City of Sumner **DESIGN COMMISSION**

PLN-2020-0015

REPORT TO THE DESIGN COMMISSION
from the DEVELOPMENT SERVICES DEPARTMENT

Project Components: Design Review for construction of a new building for Triad Machinery and site improvements including parking, equipment display yard, landscaping and pedestrian space.

CONDITIONAL USE
PERMIT SITE PLAN

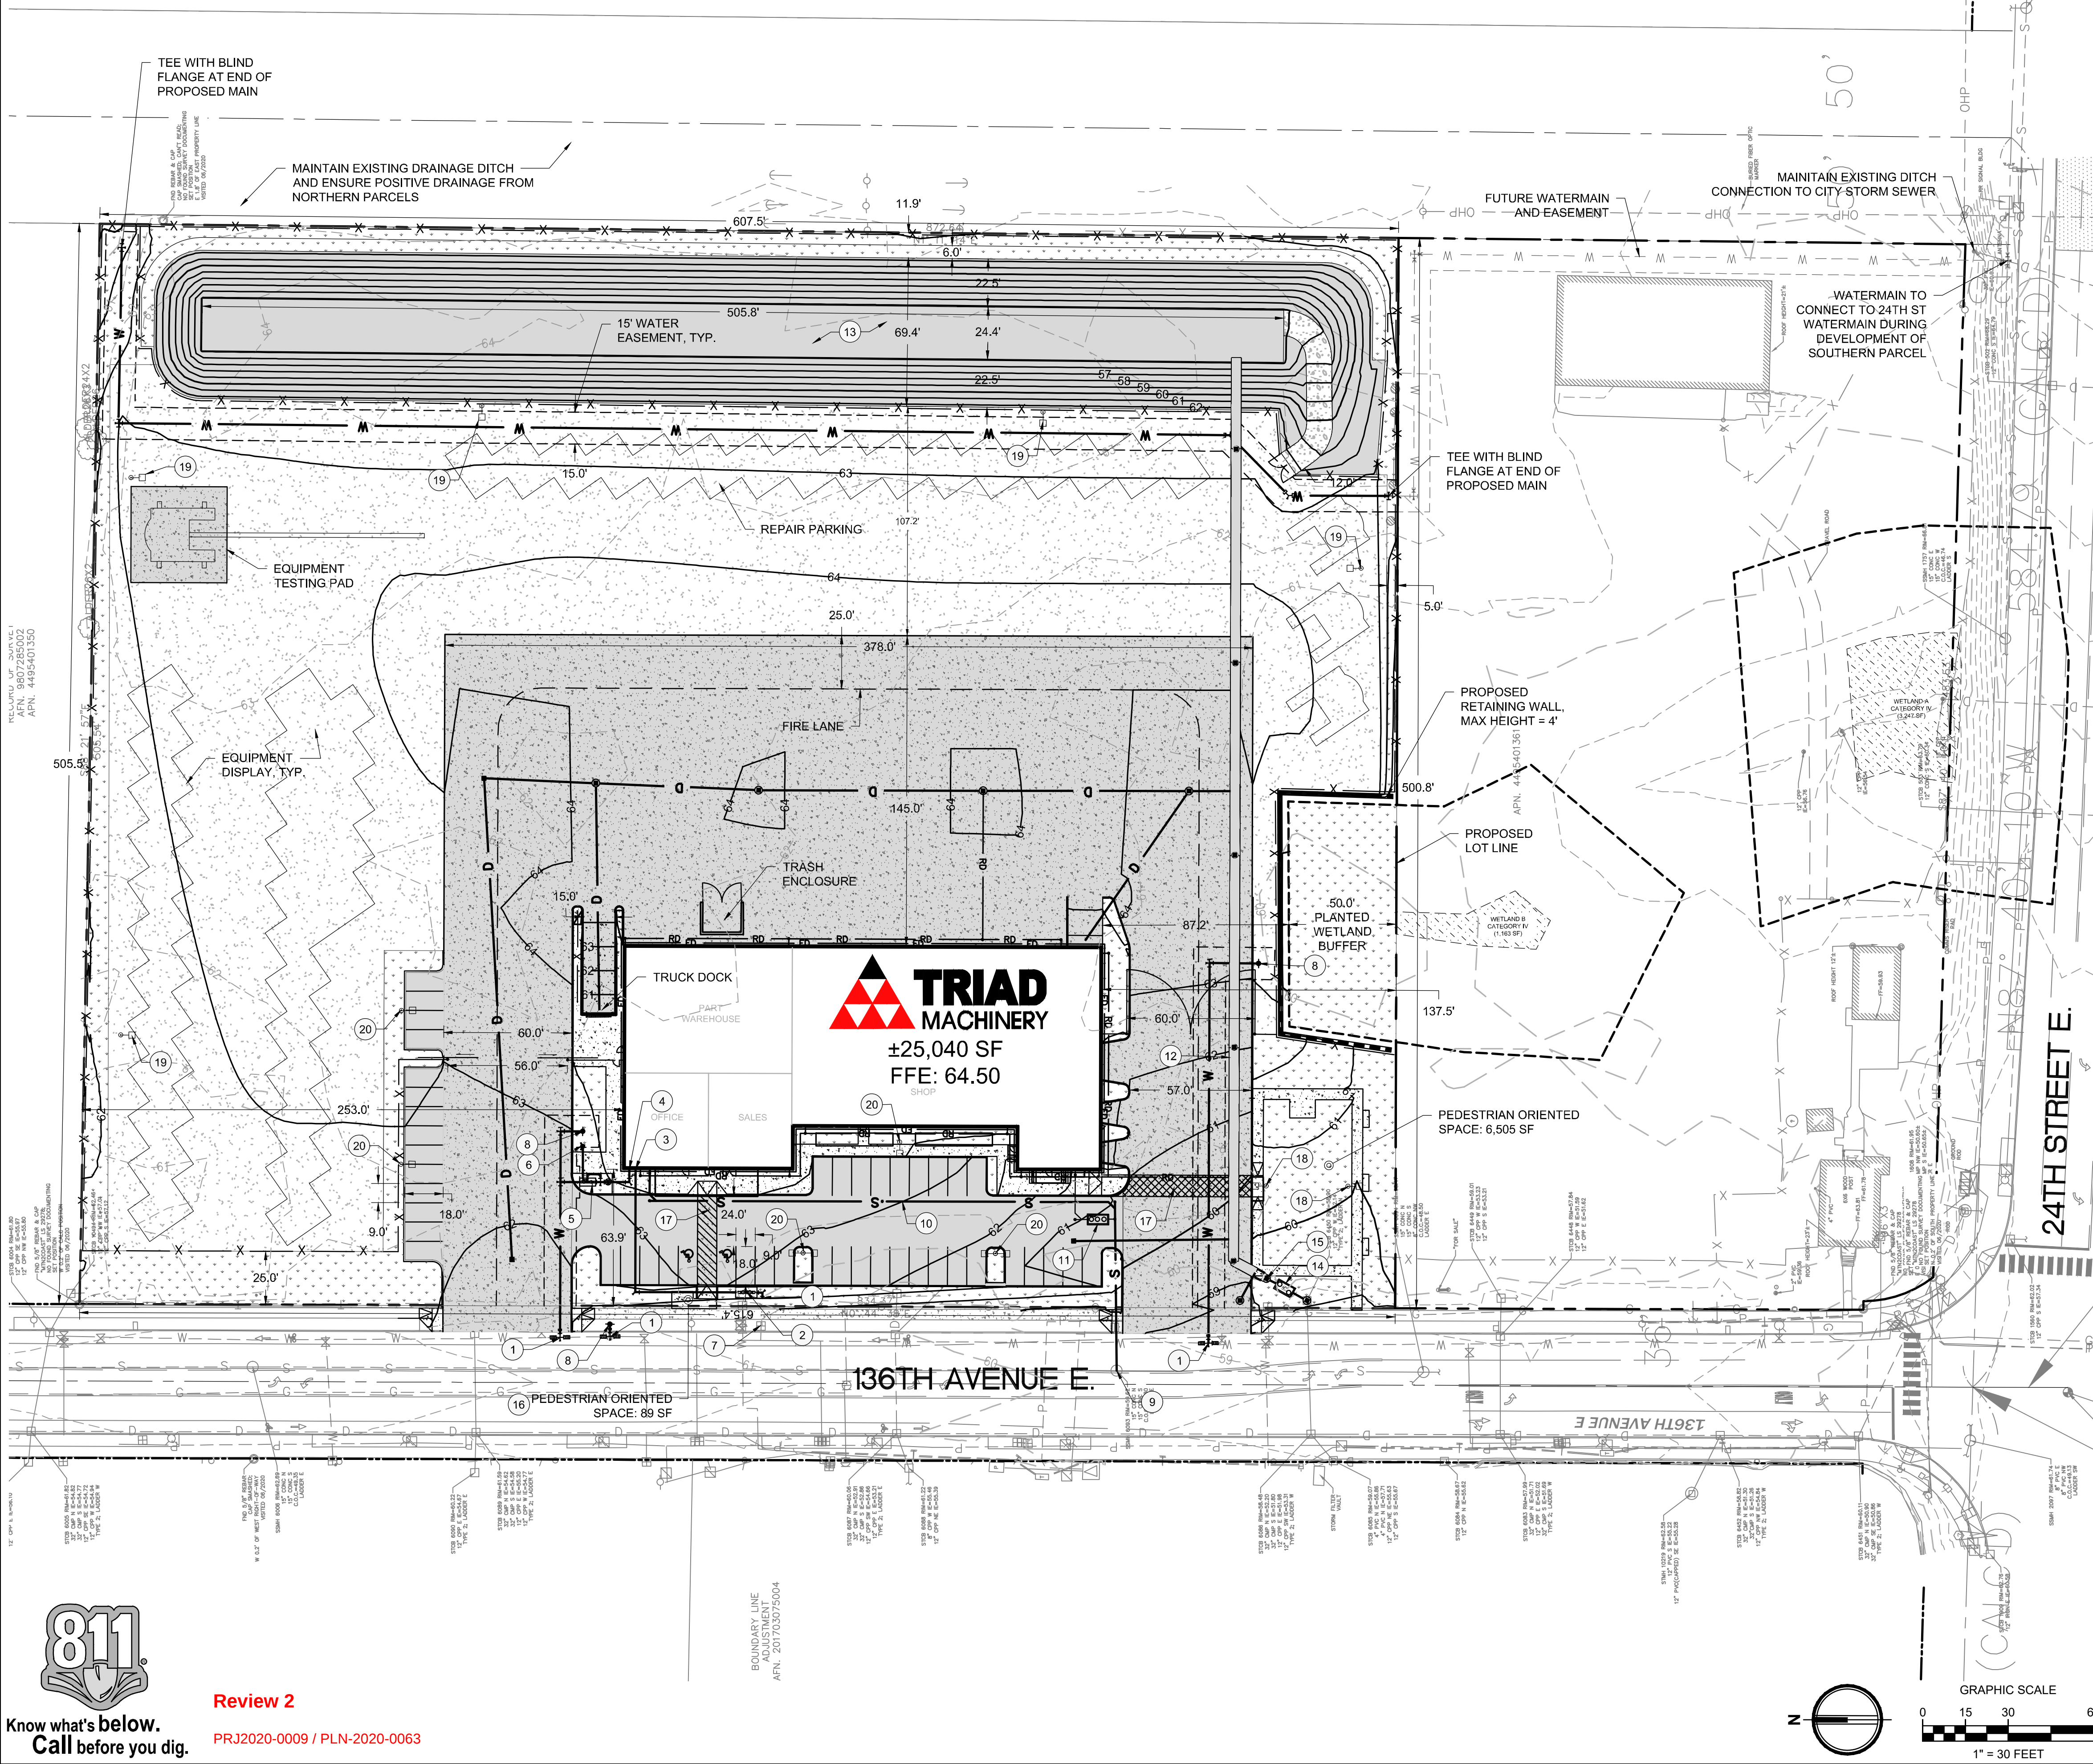
The proposed building is located 65 feet from the front or west property line, this is due to the nature of the site and the type of business going in. This project satisfies this requirement using 10 feet of type C landscaping and two pedestrian spaces along 136th. A conditioned of approval asks for landscaping to be added in the building entrance location to create additional greenery around the building entrance and a more inviting access to a building set back from the sidewalk. While this site is currently a corner lot, this design and layout is contingent on the approval of the pending short plat, which will then remove the corner function from this project and be developed later as a corner lot. The guideline is met as conditioned.

This lot is located in the IC zone and falls under subsection C above. While the project does include parking and access between the building and street, it provides a landscape buffer and pedestrian oriented space along 136th. The type of business locating at this site benefits from the proposed layout in order to provide a secure space behind the building and accessible parking out front. This proposal does include slightly over 50% parking along its frontage but does provide some to the side of the building. The proposed display area to the north does not count towards this requirement and is outright allowed under subsection (c)(ii). This guideline is met through subsection (c)(i).

This project proposes two driveway approaches along its 136th frontage which combined create approximately 120 linear feet of driveway access. Triad does have approximately 616 linear feet of frontage which would allow over 100 feet of driveway. While the 120' proposed is slightly larger than the standard commercial driveway, Triad's business requires large equipment coming in and out of the site and is generally consistent with this area of the IC zone which includes RV sales and a truck services site. In order to soften the large amount of driveway Triad is proposing approximately 370 feet of landscaping along its frontage along with two pedestrian nodes. This guideline is satisfied.

This project includes pedestrian access and circulation throughout the site. This includes access from the sidewalk on 136th at the south end of site leading to the pedestrian area and access from 136th at the mid-section of the site leading to a smaller pedestrian space and to the buildings main entrance. Plans include contrasting concrete connections across the drive aisle to the south and west of the building to ensure safe and delineated pedestrian circulation; however the parking to the north does not have a contrasting connection and given the drive aisle width of 60' a contrasting paved pedestrian connection will be required as a condition. This guideline is satisfied as conditioned

This project contains a pedestrian oriented space to the south of the building and a small node along the sidewalk access from 136th. The space to the south is the larger of the pedestrian nodes at approximately 6,505sf. This space contains a grassy lawn, concrete walkway, tables, benches and 14' lighting. This location is located adjacent to the onsite wetland buffer to create an ideal setting for pedestrian pace. A condition of approval will require landscaping along the north section of the pedestrian area except for the access point. This will provide a buffer from the drive aisle and parking for the pedestrian space. This guideline is satisfied as conditioned.

An additional pedestrian walkway constructed of a contrasting paved material shall be provided to connect the northern parking area to either the sidewalk or building entrance in order to provide durable safe walkways and promote safety between vehicles and pedestrians.

Bicycle parking in compliance with SMC 18.42.085 shall be shown on the site plans at time of building permit application. Bike racks should be located near the main building entrance and southern pedestrian space.

PLANTING PLAN

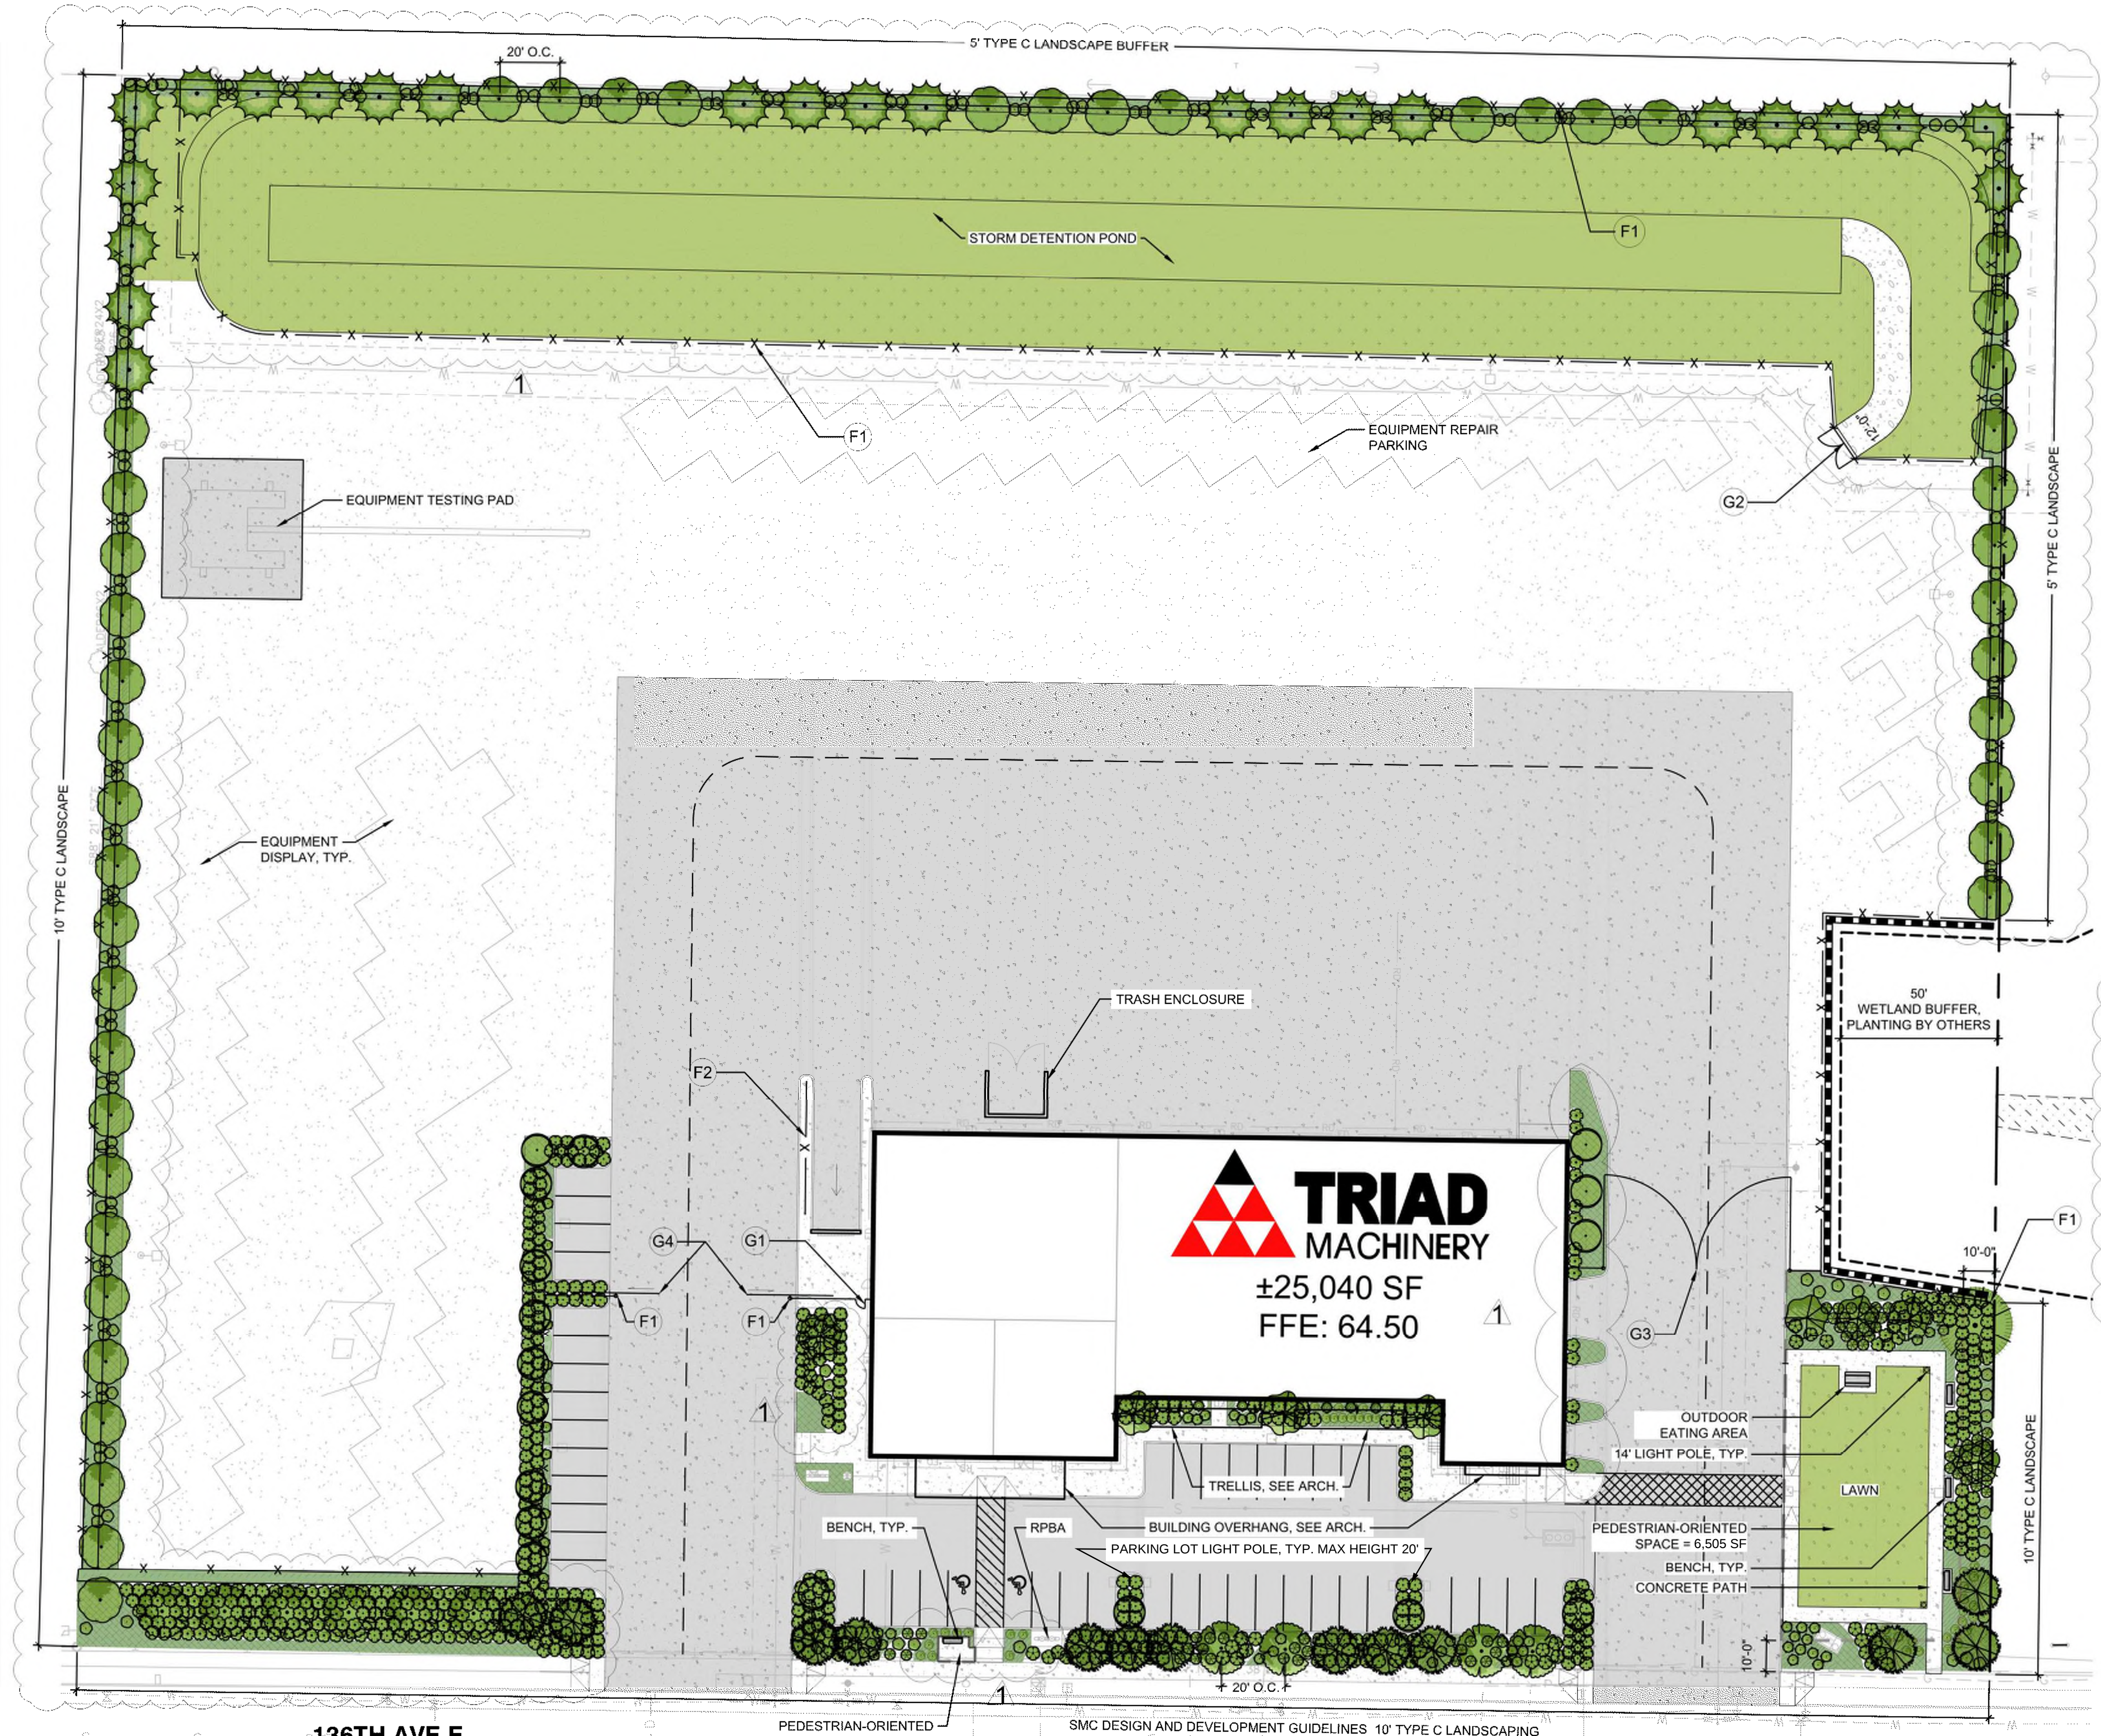
This proposal includes 10 feet of type C landscaping between parking areas and 136th as shown on the landscape plans, this guideline is satisfied.

Landscape planters should be added at the primary building entrance to create additional landscaping around the building entrance and offset the large setback and parking between the building and street.

Landscape planters shall be added along the northern section of the pedestrian space located to the south of the building. This will ensure that the pedestrian space is screened and protected from the drive aisle and parking area.
